**Morganza to the Gulf of Mexico Risk Reduction Project  
Biological Assessment (BA)  
Errata Sheet  
Updated March 21, 2013**

The Fish and Wildlife Service (Service) has prepared a Fish and Wildlife Coordination Act Report on the U.S. Army Corps of Engineers' (Corps) Mississippi River and Tributaries – Morganza to the Gulf of Mexico, Louisiana, Post-Authorization Change (PAC) report. That PAC report is being prepared to quantify costs and impacts of the Morganza, Louisiana, to the Gulf of Mexico Project (MTG) authorized under the 2007 Water Resources Development Act. That PAC report also examines the feasibility, costs, and impacts associated with two levee height alternatives, both of which are located on the alignment selected in the 2002 Feasibility Report. The PAC alternatives would protect against flooding from a 1 percent annual chance of occurrence storm (100-year frequency) and a 3 percent annual chance of occurrence storm (35-year frequency). The 100-yr frequency protection system has been chosen as the Tentatively Selected Plan. The PAC report will programmatically evaluate most project features; however, feasibility level evaluations are desired for the “constructable”

Figure 1. Potential areas affected by constructable features

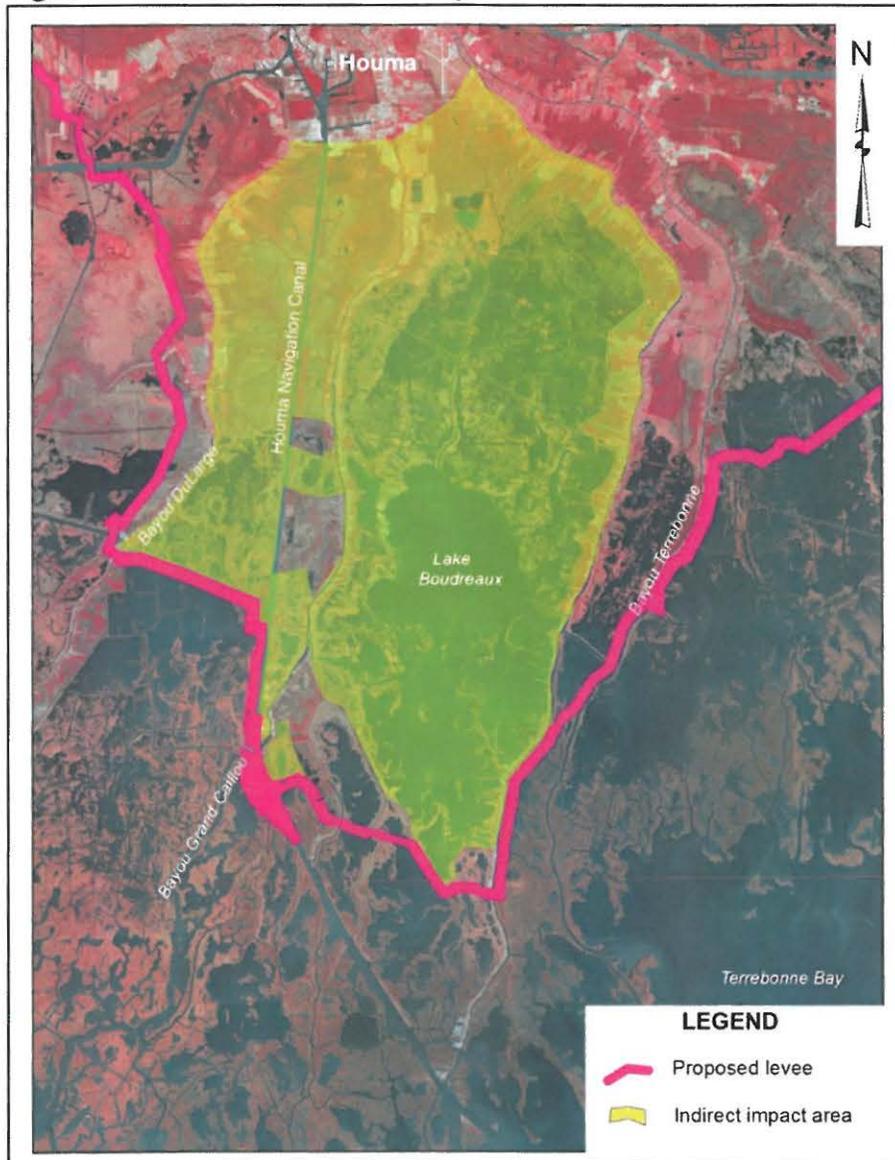
Page 15. The first paragraph references mitigation south of Falgout Canal and in Felix Lake as being located in subunits identified as B13 and B15, respectively. Figure 6 on Page 8 has the subunits labeled differently. However, NMFS concurs that B13 and B15 correspond with the described locations based on a different map provided during the planning process. It is suggested either Figure 8 be replaced with the alternative map or a second map be appended to the report to provide clarification.

**Figure 1. ALIGNMENT AND STRUCTURES OF THE  
1% ANNUAL EXCEEDANCE PROBABILITY STORM SURGE RISK REDUCTION SYSTEM ALTERNATIVE**  
Morganza to the Gulf of Mexico, Louisiana  
Revised Programmatic Environmental Impact Statement

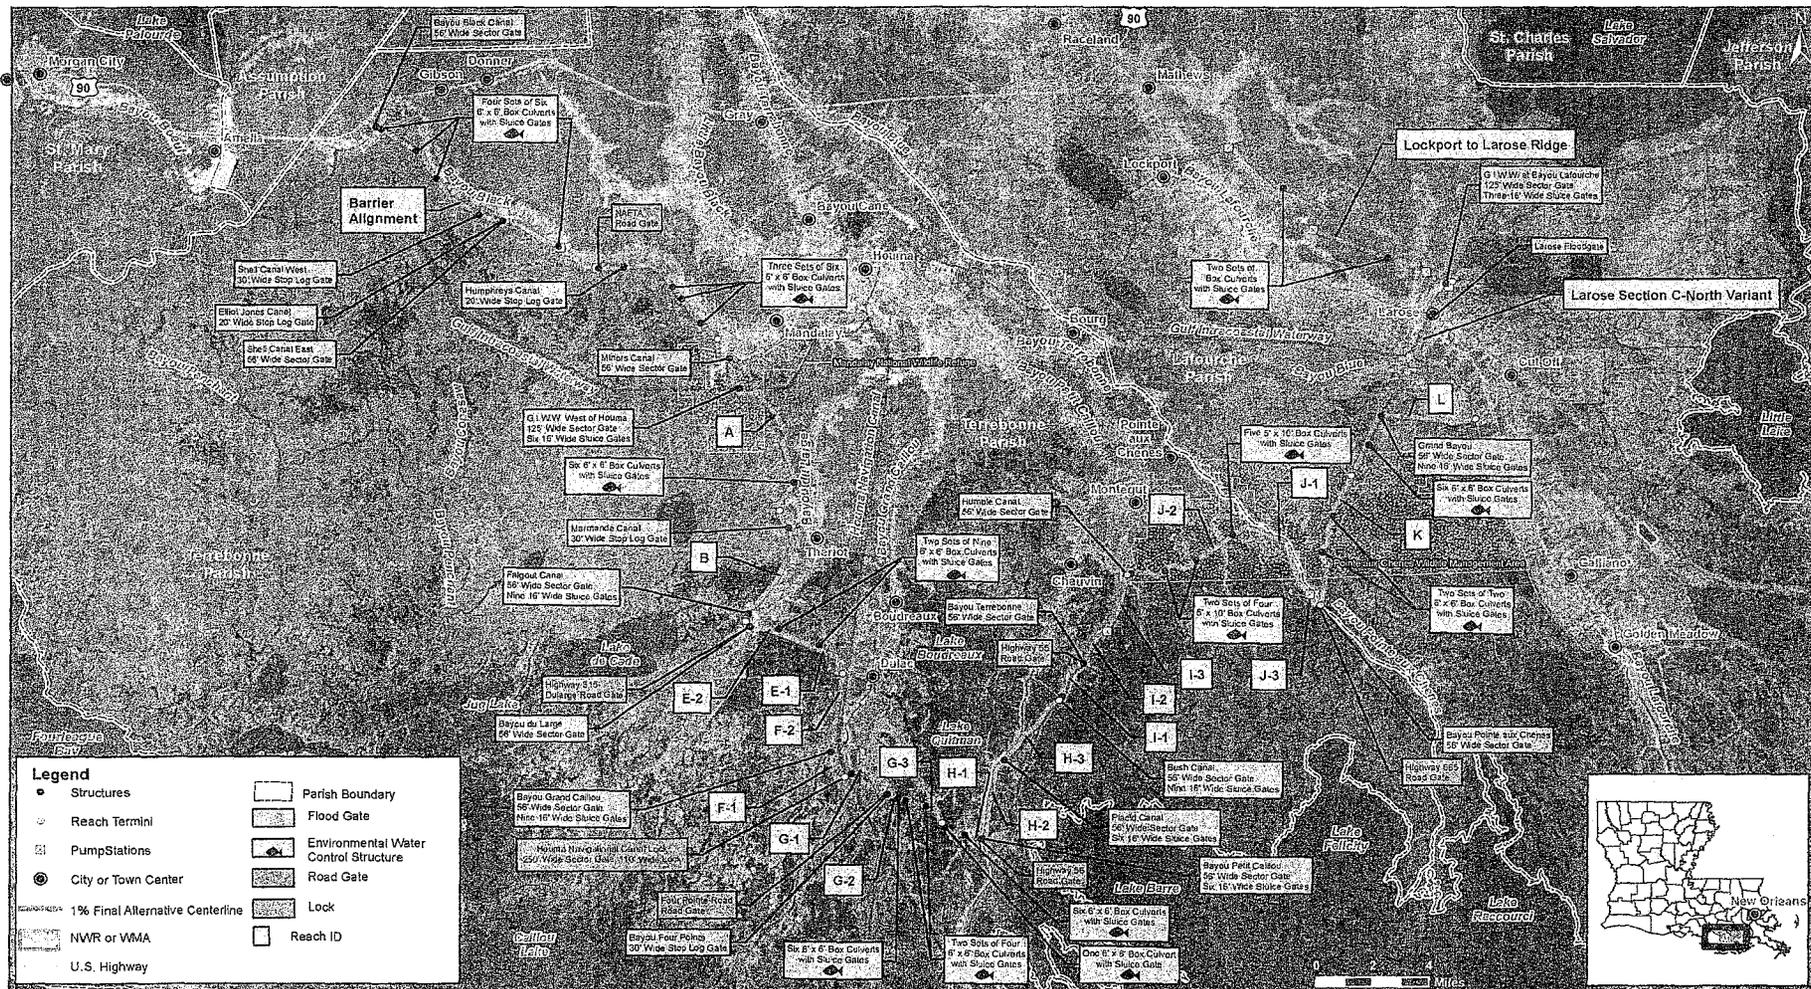
19. Figures 12 and 14, C-north and Lockport to Larose Levee Alignment: Figures appear to incorrectly show the location of the GIWW floodgates instead of further east where the alignment crosses this waterway.
